**US Presentation on AP1000 Review
Plans and Status
MDEP Meeting
March 22-24, 2010**

by SUN Zaozhan

The Review of AP1000 in China

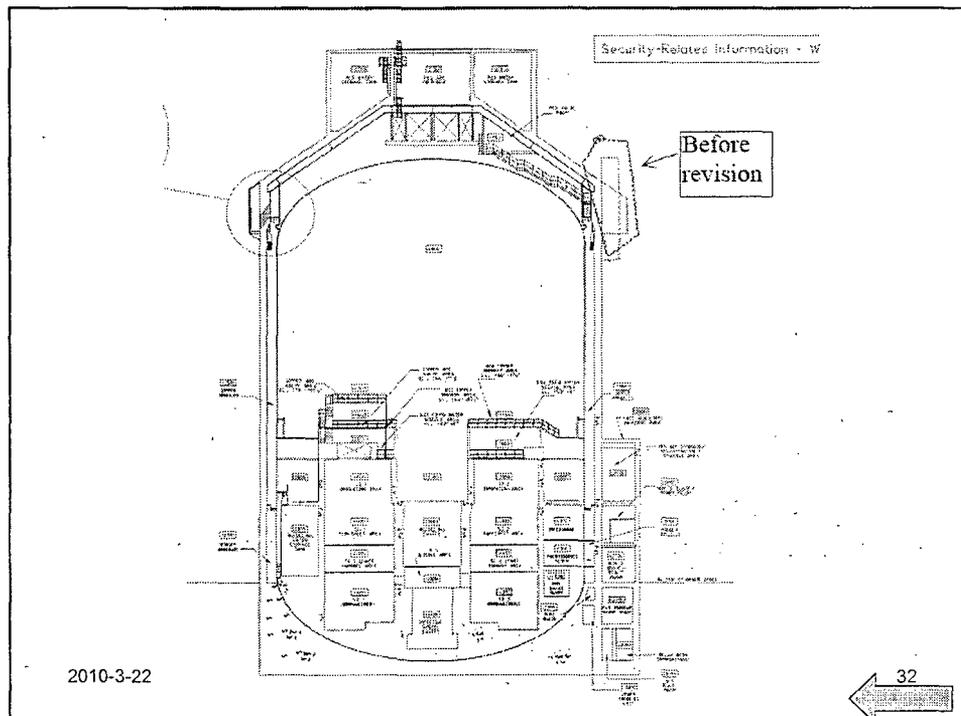
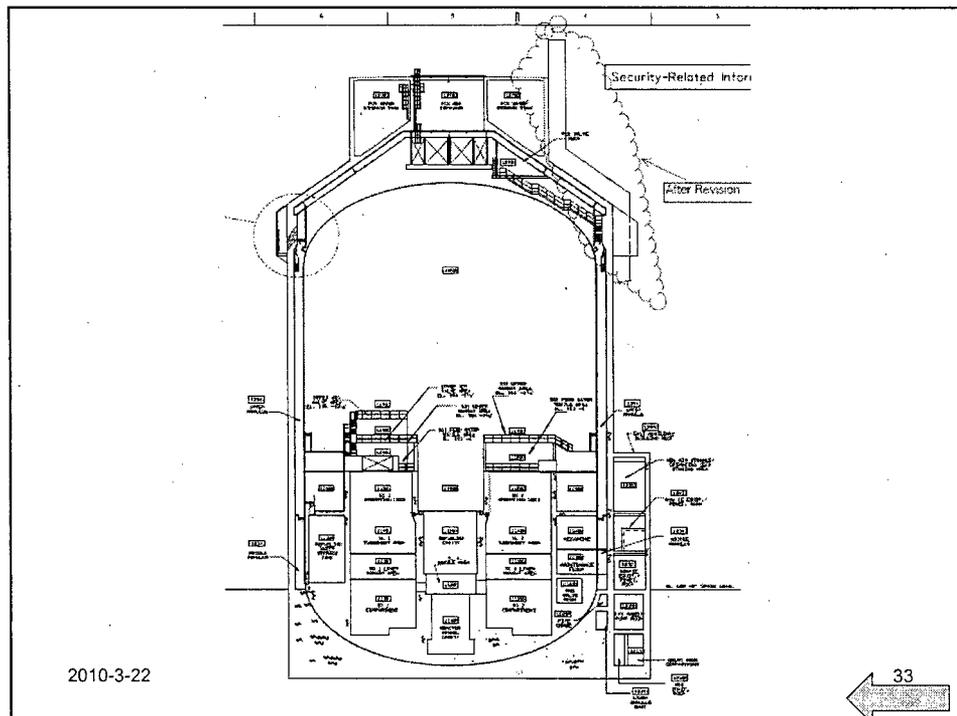
- The height of the exhaust vent stack is lower than the height of main structure nearby, it is different from our practice.
 - GB-12697 states that the exhaust vent stack must be at least five (5) meters higher than any buildings within 200 meters in the vicinity of the stack.
- The Applicant shall, within 6 months of CP, furnish a design change proposal to change the height of the exhaust vent stack.
- Proposal of design modification by the Applicant
 - Before revision
 - After revision

- CP10-5: The Applicant shall, within 6 months after CP, furnish a design change proposal to change the height of the exhaust vent stack.
